**County of San Diego  
Planning & Development Services  
BUILDING DIVISION**

<b>ACCESSIBILITY CORRECTION LIST</b> Public Accommodations & Commercial Buildings	<b>1B</b>
<b>Site Accessibility and Exterior Routes of Travel</b>

**FIGURE 11B-302.3  
ELONGATED OPENINGS IN FLOOR OR C**

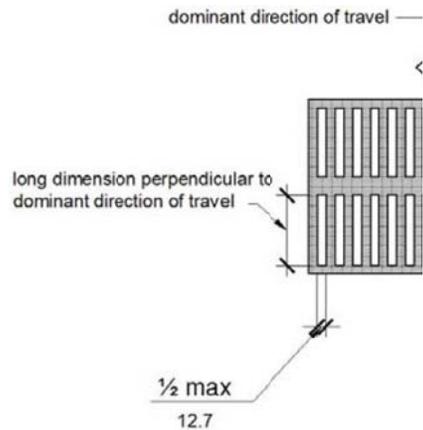
14. For abrupt changes in level greater than 1/2 inch on accessible routes, provide pedestri  
**Exception:** Changes in level served by curb ramps shall meet requirements of accessil
15. Identify on site accessibility plan any grates or similar openings located on accessible r per CBC Figure 11B-302.3 with any elongated openings placed perpendicular to domin
